AMD-K6[®]

Processor Revision Guide

Model 7

Publication # 21846	Rev: E	Amendment/0
Issue Date: March 1998

Figure 1. AMD-K6 Processor Assertion of HLDA Due to Simultaneous $\overline{\text{BOFF}}$ /HOLD Assertion

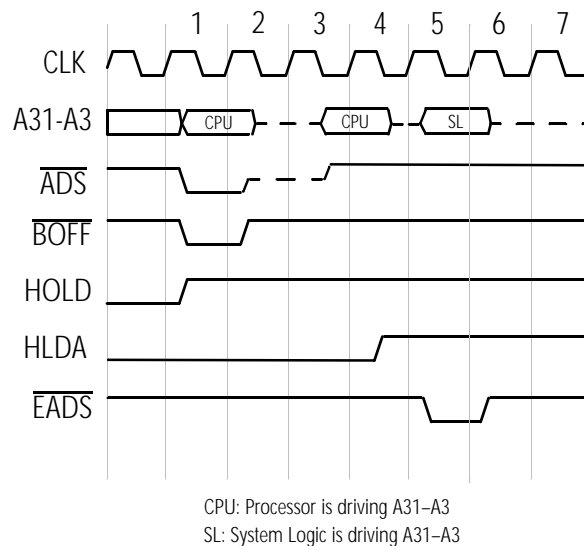
Non-conformance. If $\overline{\text{BOFF}}$ and HOLD are sampled asserted on the same clock edge that negates $\overline{\text{ADS}}$, the processor asserts HLDA two clock edges after HOLD is sampled asserted.

Potential Effect on System. There are three potential effects of this erratum to consider:

- If the system logic asserts $\overline{\text{BOFF}}$ for a duration of one clock, anticipates the assertion of HLDA in clock 3 (see Figure 1)—which is the normal specified operation—and drives the address bus and $\overline{\text{EADS}}$ for an inquire cycle in clock 3, then the processor will not sample $\overline{\text{EADS}}$ asserted. In addition, address bus contention will occur in clock 3.

- If the system logic asserts $\overline{\text{BOFF}}$ for a duration of two clocks, anticipates the assertion of HLDA in clock 3, and drives the address bus and $\overline{\text{EADS}}$ for an inquire cycle in clock 3, then the processor will not sample $\overline{\text{EADS}}$ asserted. (No address bus contention occurs in this case.)

- If the system logic asserts $\overline{\text{BOFF}}$ for a duration of one clock, anticipates the assertion of HLDA in clock 3, and drives the address bus and $\overline{\text{EADS}}$ for an inquire cycle in clock 4, then address bus contention may occur in clock 4. (The processor will sample $\overline{\text{EADS}}$ asserted in this case.)

If the processor does not sample $\overline{\text{EADS}}$ asserted during an inquire cycle, cache/memory incoherency will occur. Address bus contention can affect the reliability of the processor and the system logic.

Suggested Workaround. The system logic must sample the assertion of HLDA before asserting $\overline{\text{EADS}}$ and driving the address bus for an inquire cycle—as shown in clock 5 of Figure 1.
